# Sigenergy Energy Controllers voluntary recall – affected approved inverters and batteries

To help resolve the issue, Sigenergy submitted a component change request to the Clean Energy Council with a new OT terminal-style AC connection design for all affected CEC listed products. This component change was approved.

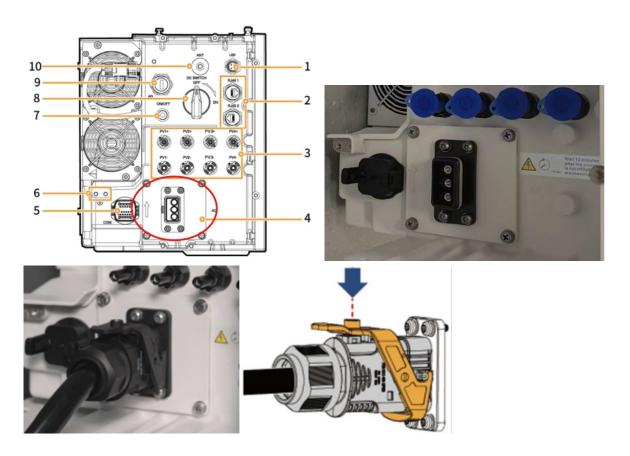
The affected units can be identified by one of the following model numbers and the type of AC connection on the left side of the inverter.

The quick-connect AC plugs (requiring ferrules and crimping) on recalled models look like this:

### The new models with OT terminal-style AC connections look like this:
